Re: West Sewage Treatment Plant (STP) Improvements
Change Order No. 4
City of Crest Hill, Illinois (City)

CHANGE ORDER NO. 4

PROJECT: West Sewage Treatment Plant (STP) Improvements
OWNER: City of Crest Hill, Illinois
CONTRACT: 1-2022
CONTRACTOR: Vissering Construction Company

012-01 Drawing 15-ASM3.01 (Sheet 63)

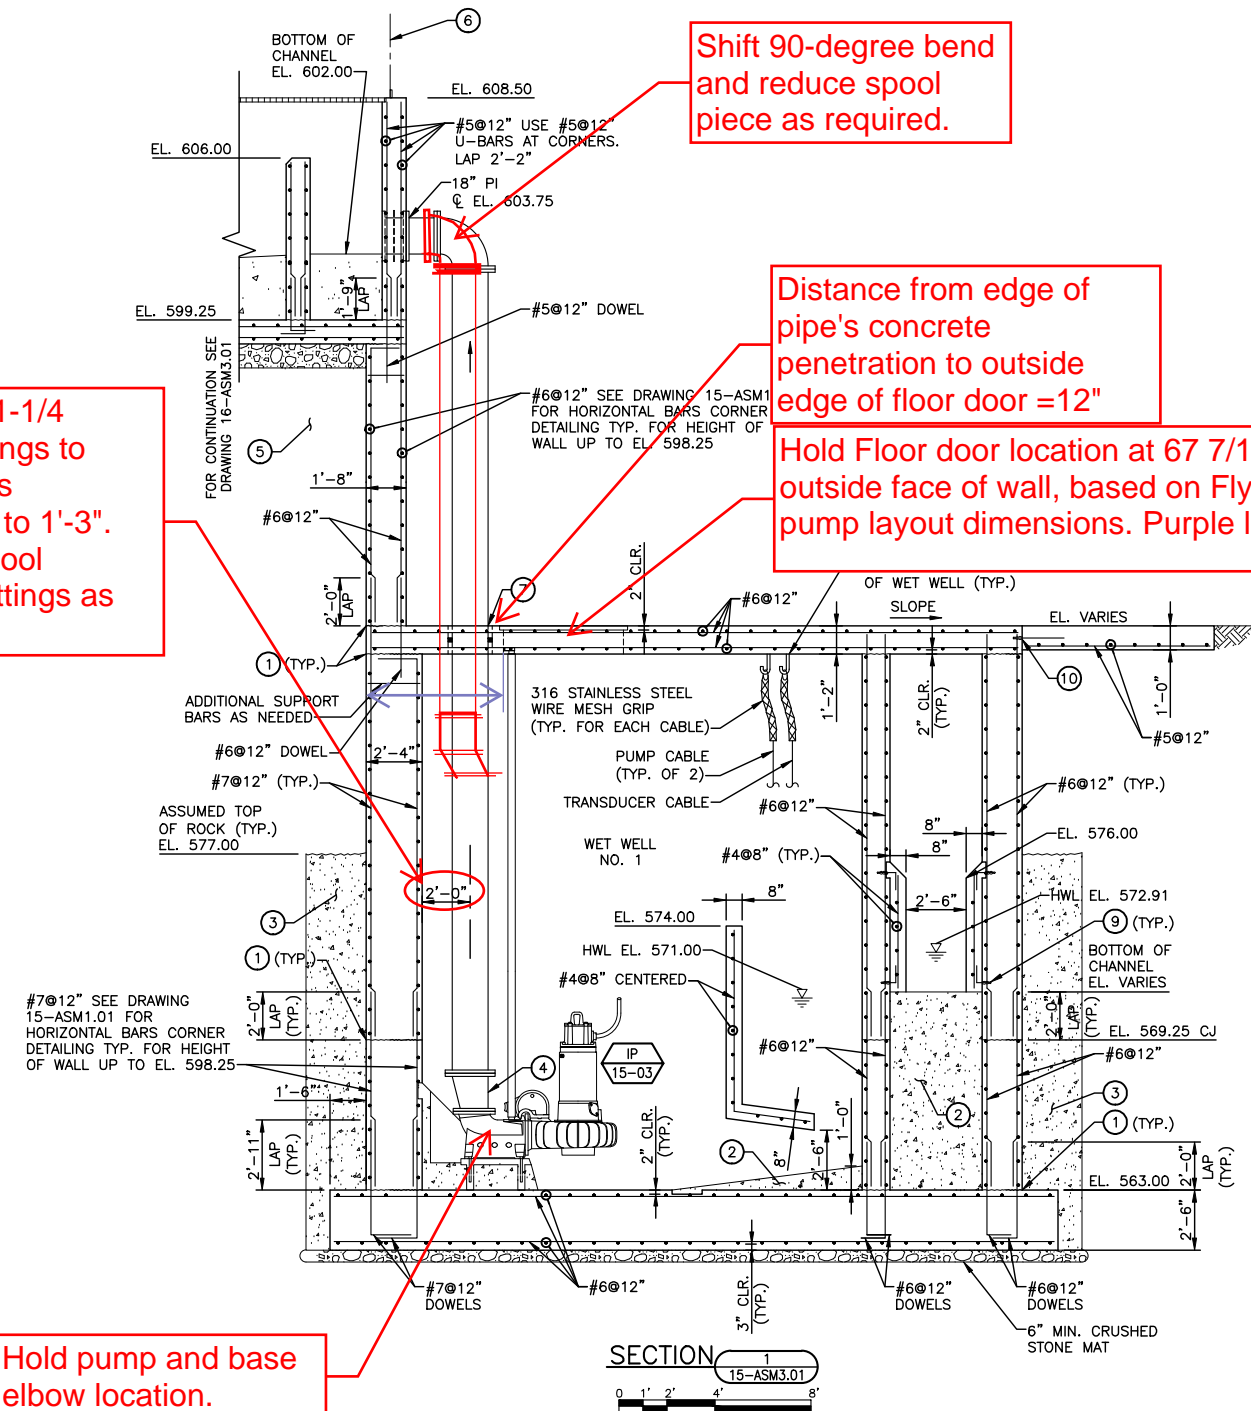
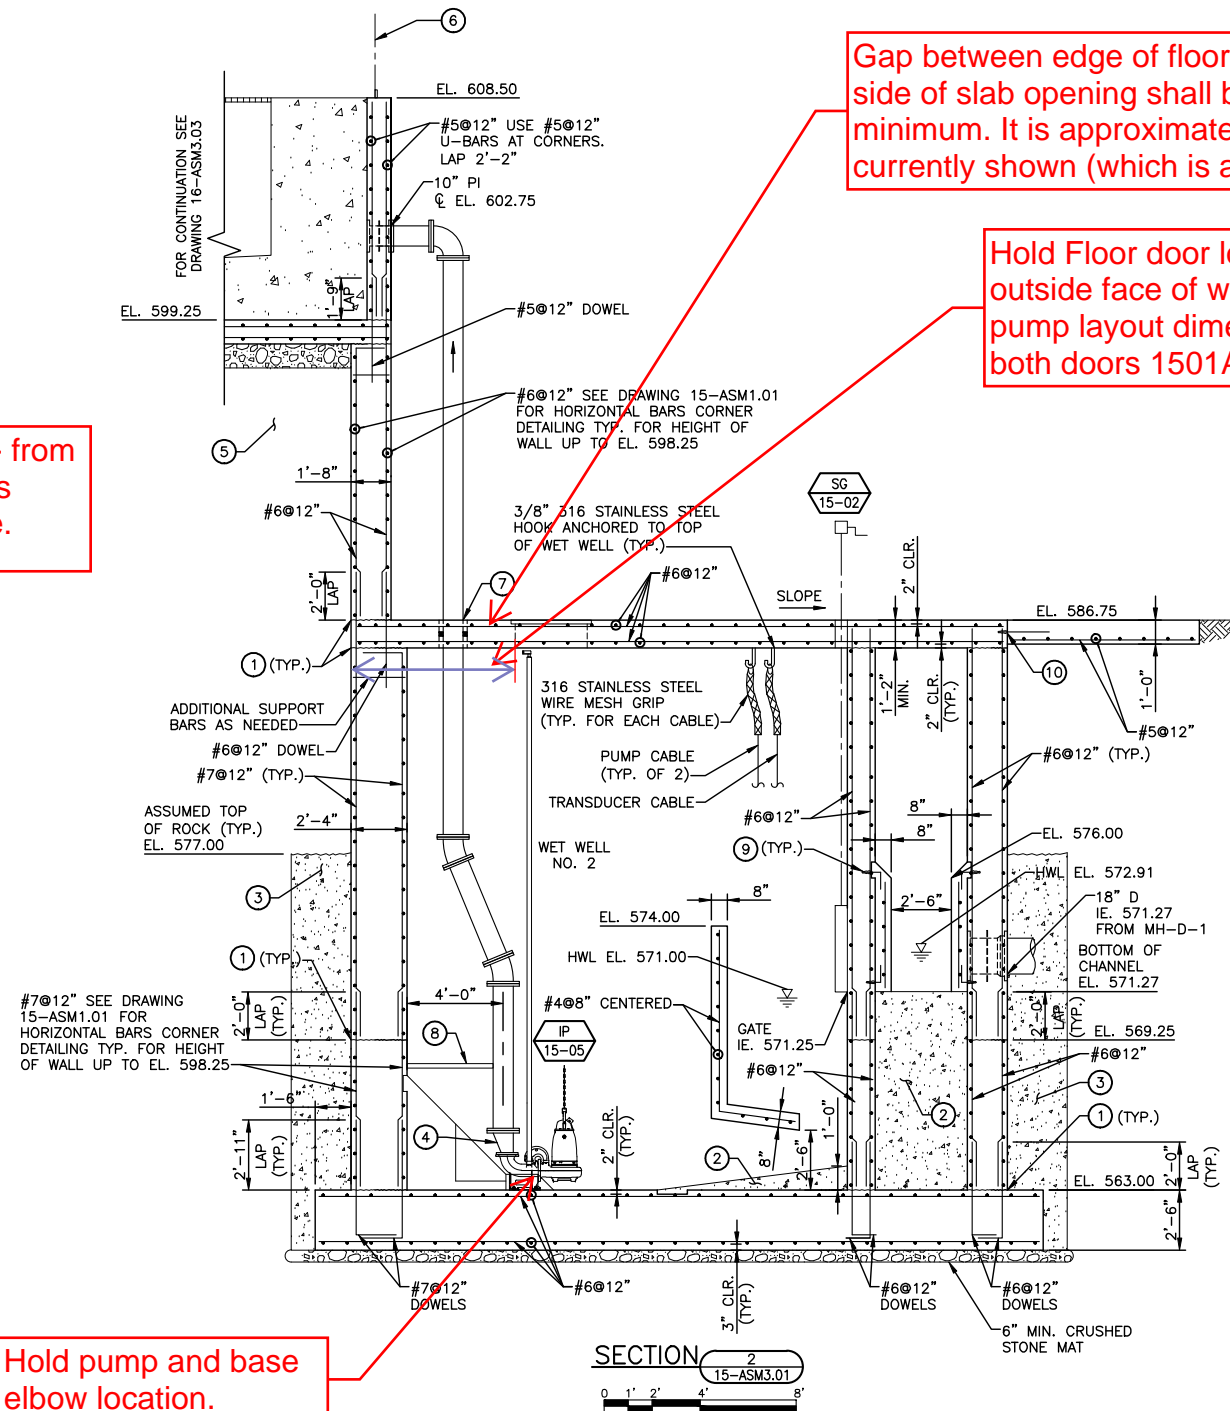
Hold Floor door location at 67 7/16"- from outside face of wall, based on Flygt's pump layout dimensions. Purple line.

Gap between edge of floor door and right side of slab opening shall be 12" minimum. It is approximately 24" as currently shown (which is acceptable).

Hold Floor door location at 82"- from outside face of wall, based on Flygt's pump layout dimensions. Purple line. Typ both doors 1501A and D.

Hold pump and base elbow location.

Hold pump and base elbow location.

013-02 Drawing C45-ASM1.01 (Sheet 117)

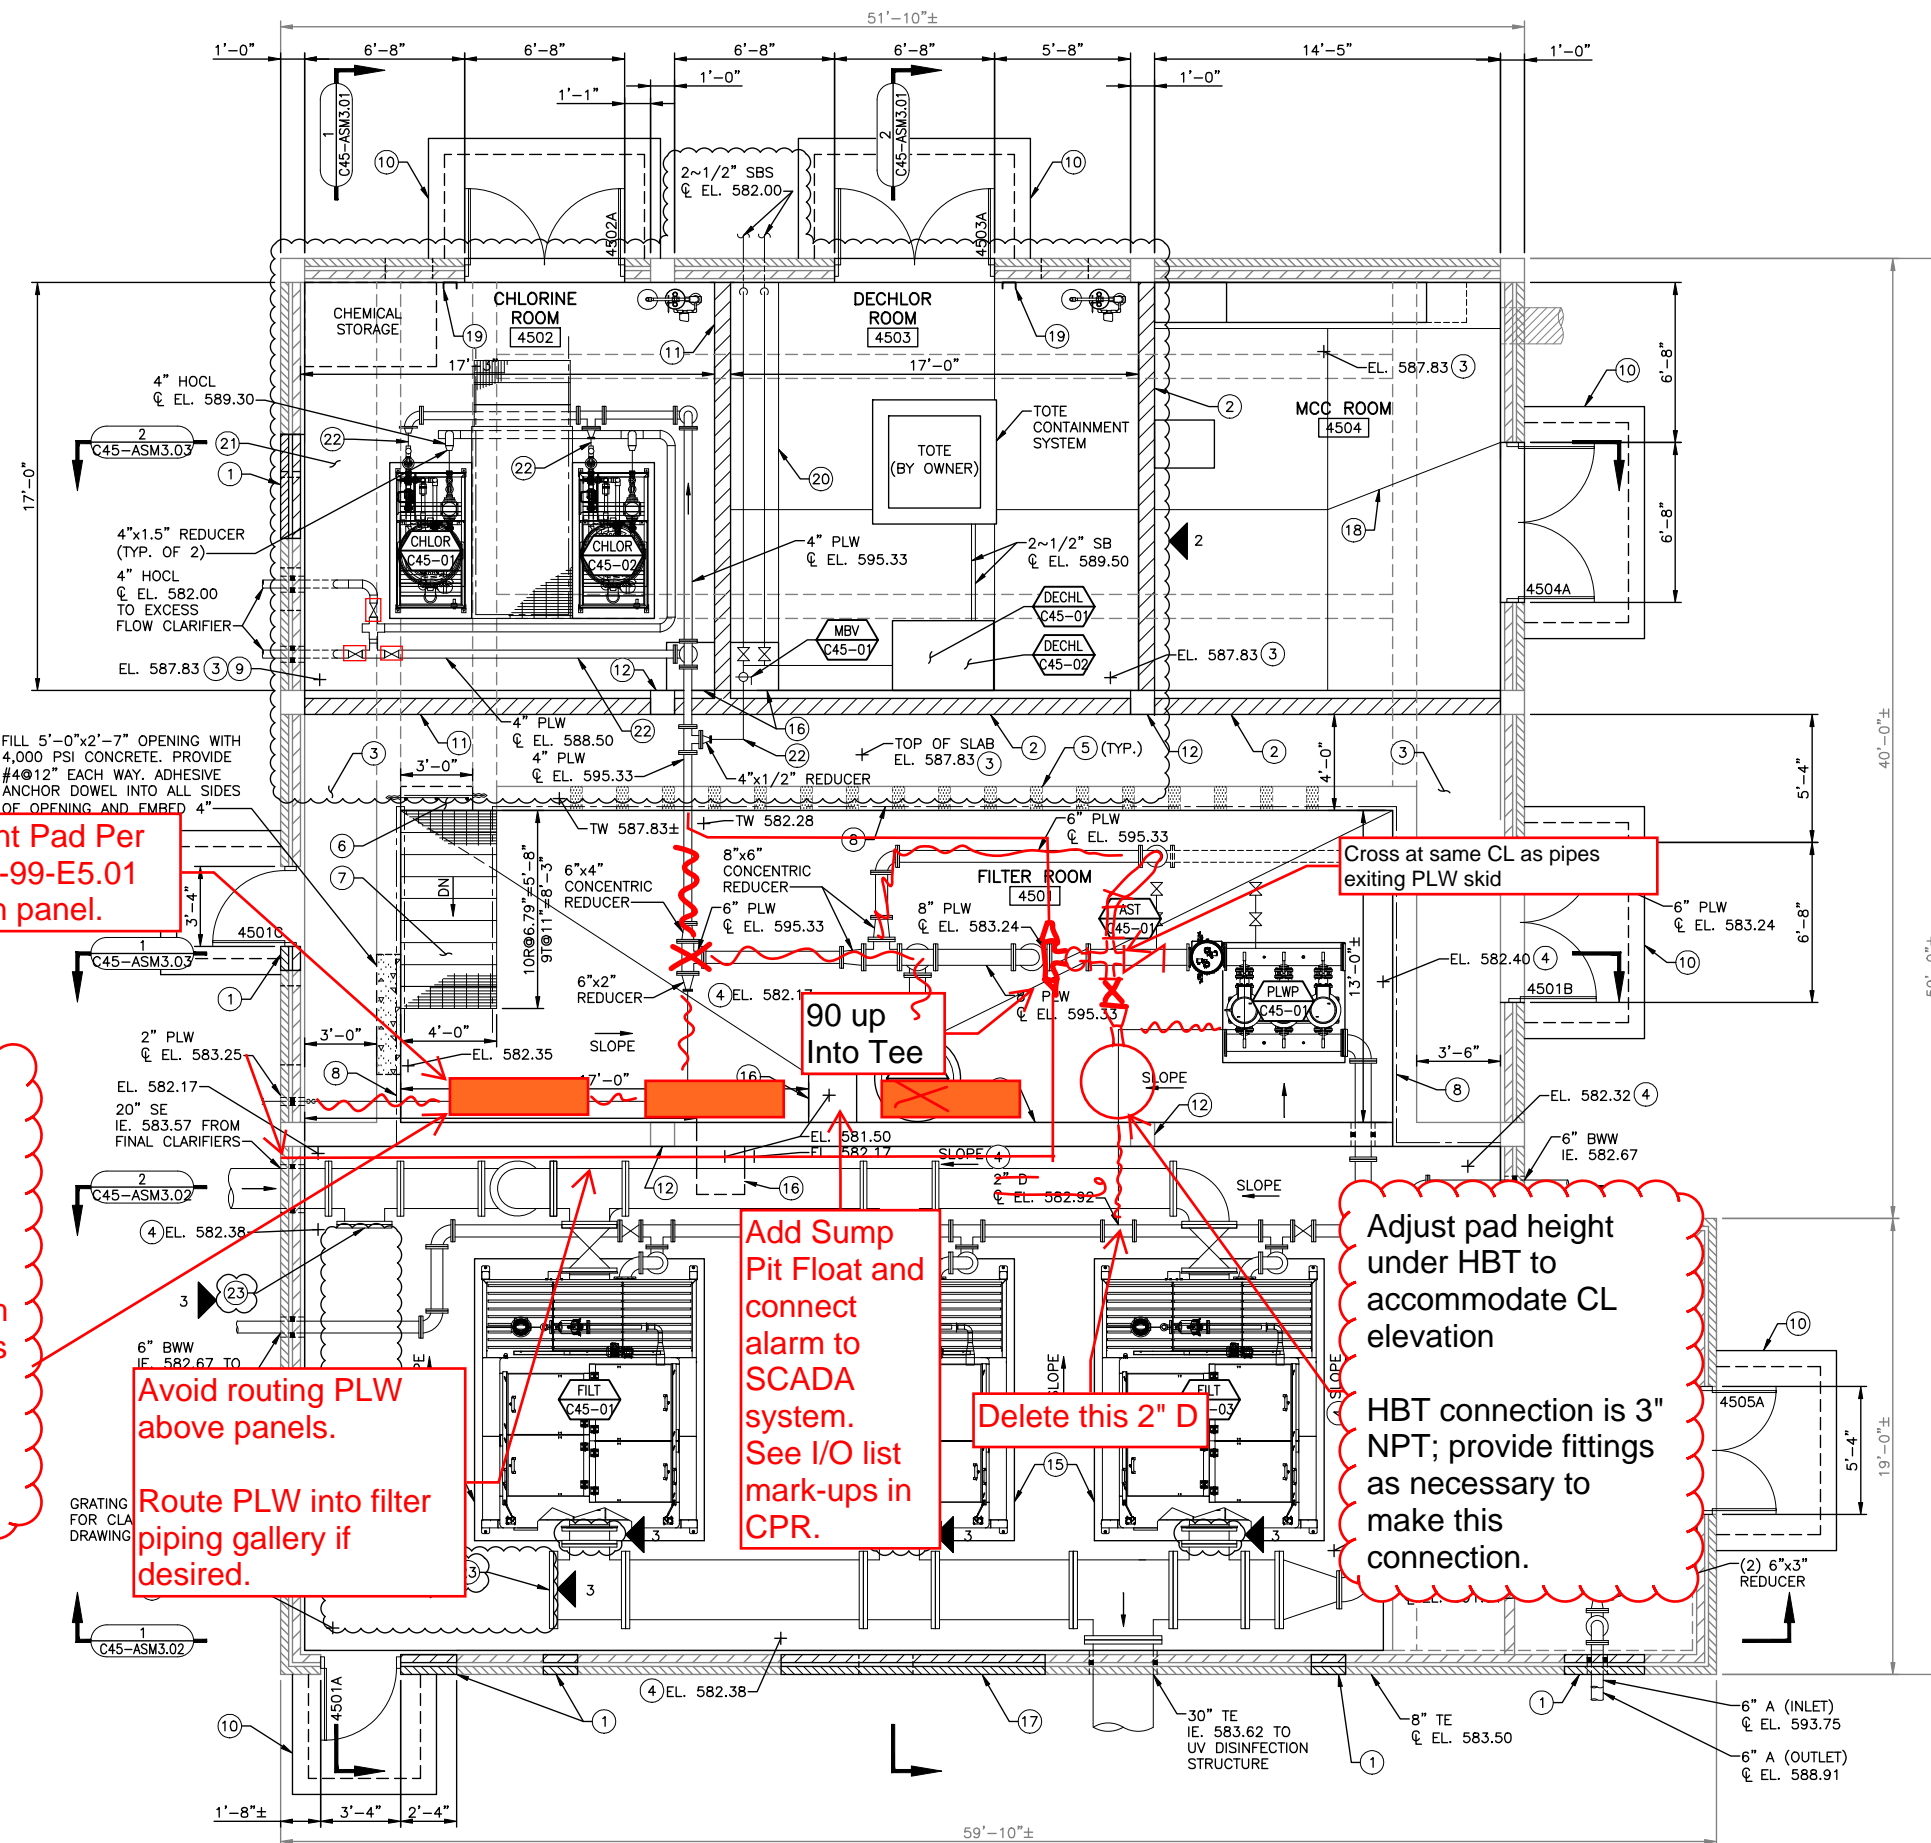
- Drawing C45-ASM1.01 (Sheet 117)
 - Relocate Filter Control Panels within Structure C45 from platform to where shown on marked up drawing
 - Extend Filter Control Panels conduit and wiring to new locations
 - F&I (1) ¾ conduit and (2) #14 conductors from SCC to sump pit float

See comments on attached PDF.

Clarification: This CPR is required based on the height of the filter control panels. The manufacturer stated that the panel height could not be modified.

015-01 Drawing E70-E1.01 (Sheet 197)

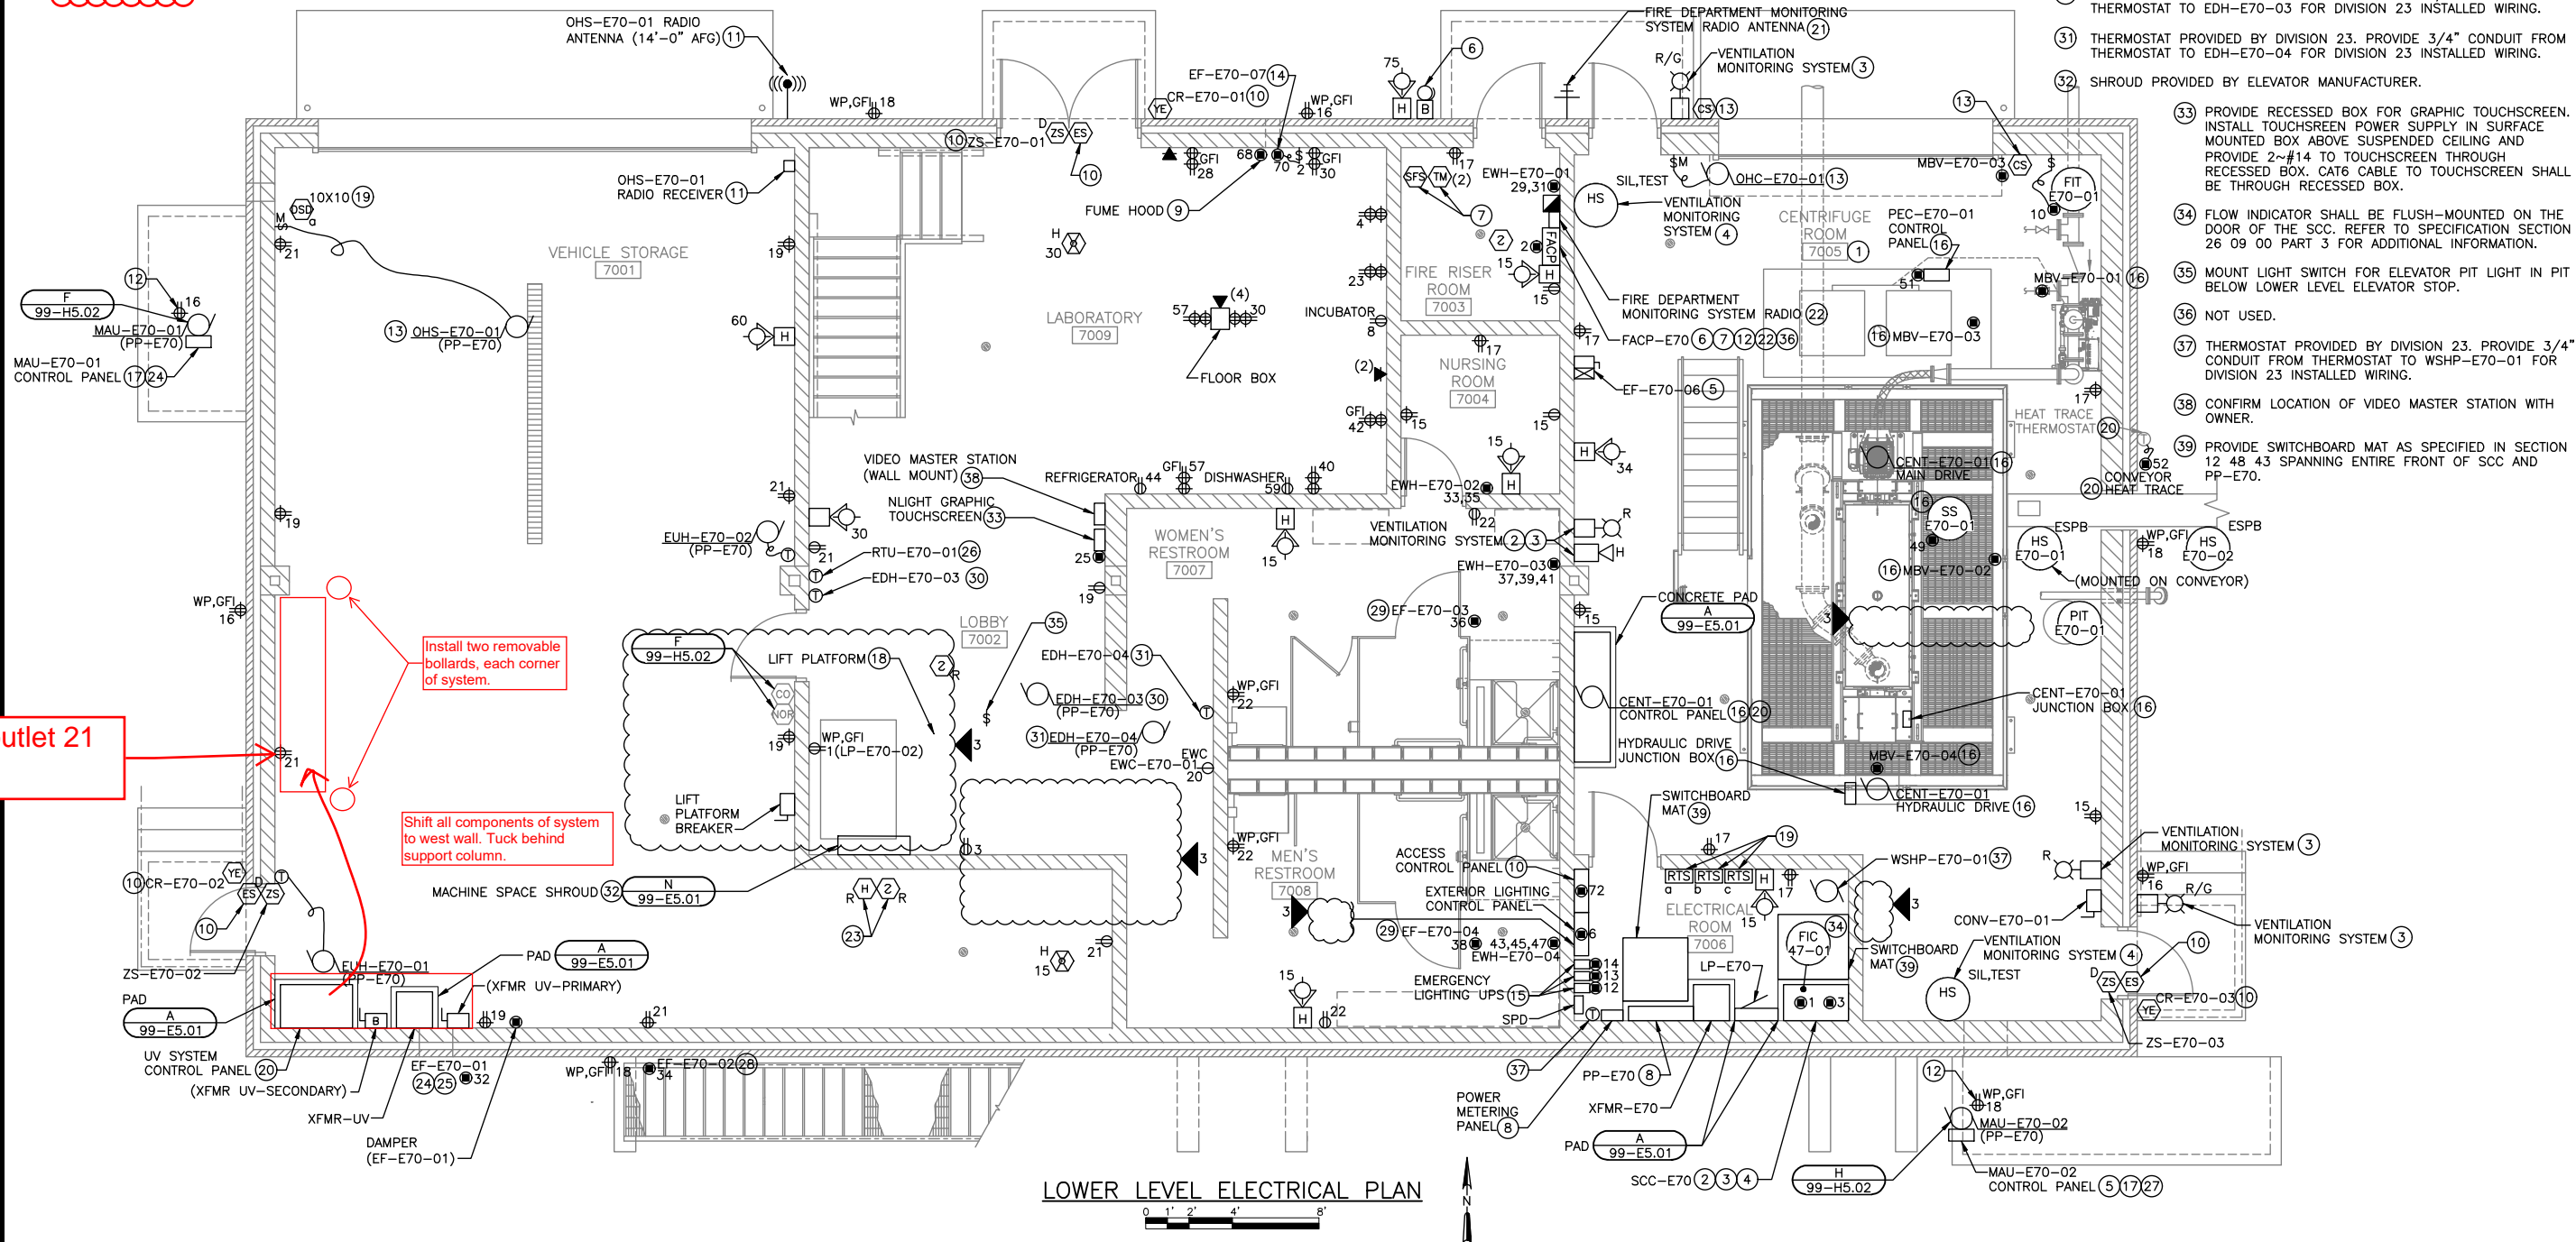
See comments on attached PDF.

- Drawing E70-E1.01 (Sheet 197)
 - Modify the distance between the Structure 47 - UV Disinfection equipment and its respective control panels within the Structure E70 Dewatering and Operations Building by moving the UV System Control Panel as shown in the markups
